MEMORANDUM

From:	Built Heritage Officer		
Service	Green Infrastructure	App No:	251653
Address:	2 Rose Street, Wokingham, RG40 1XU.		
Proposal:	Application for Listed Building Consent for the proposed internal and external repair works including renewing the existing kitchen and bathrooms, repairing and redecoration of windows, repointing and redecoration of external doors, new third floor windows, plus installation of 2no. floor mounted air con units with acoustic screening to rear elevation (part-retrospective)		
Heritage Asset:	Wigmore Lodge, 2 Rose Street – is a grade II listed building and has been since 1951. Wokingham Town Centre Conservation Area. Listed Buildings and conservation areas are classed as designated heritage assets under the NPPF (2024) and in the Council's Local Plan policies.		
Site Visit Made:	Yes, on 22/07/25

Proposed floor plans (extract of drawing E05 rev. P1)

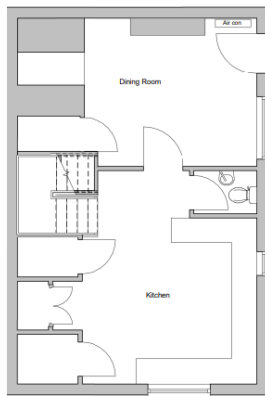
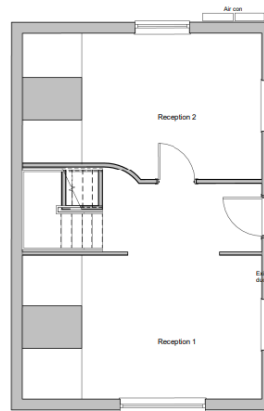
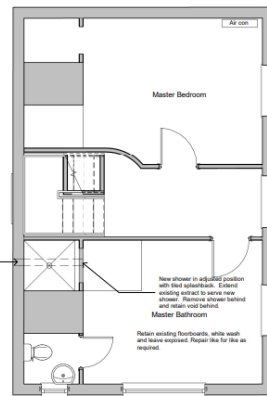
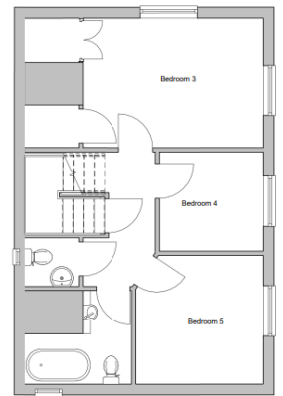
With respect to the submitted existing and proposed floor plans (drawing E05 rev. P1) it has been noted on visiting the property that it appears the staircase leading to the basement/kitchen maybe incorrectly depicted, as the wall either side of the door opening into the dining room of the basement are in line with each other, with the wall abutting directly the bottom of the steps on its RHS.

Basement stairs down into basement kitchen. 1st Floor Bathroom/shower. 2nd floor shower room (not WC room)

Originally submitted Proposed Elevation drawing E04 Rev.P1 clearly states small 2nd floor window to be replaced.

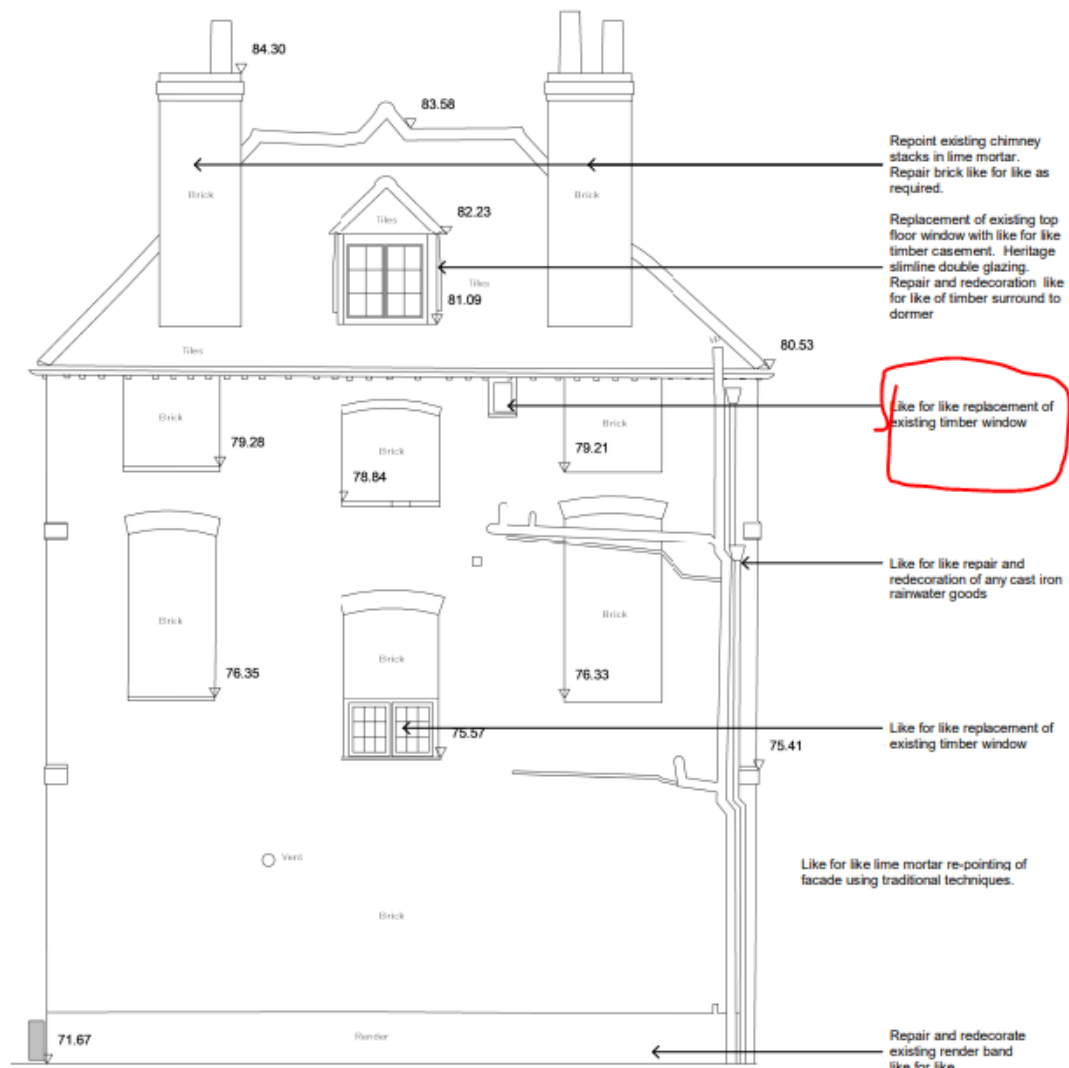
It is stated the existing windows from basement level up to, and including second floor levels are to be retained, repaired as needed and redecorated. The exception being that of a small square window on the south-west rear elevation that services a small second floor shower room. This window which is not considered to hold any historic value in itself, being a more recent adaptation to the building, and at the time of visiting the property had no glass in it, is shown on the proposed plans to be replaced, for which no objection is raised here. With respect to that window on the original comments it had been incorrectly stated that the proposed plans did not make clear works to the window when it did and consequently somewhat erroneously with the amended plans of the second floor bathroom window on the south-east facing side elevation of the property is proposed to now be replaced. However this is being a historic window that appears to be in fair condition such that its replacement would not be supported here and the proposed drawing accordingly amended to show the window is to be repaired and redecorated rather than replaced.

The second floor bathroom window on the south-east facing side elevation of the property to be retained and not replaced.

Subject to the removal from the amended plans received on 8th September of the erroneously sought replacement of the second floor bathroom window on the south-east facing side elevation of the property, those amendment to the drawings as proposed (which now omit the rendering of the brick banding to the side elevations of the property) and clarification on the matter of the fixing of the fence screening, Built Heritage no longer raise any objection on that basis recommend consent be given subject to conditions.
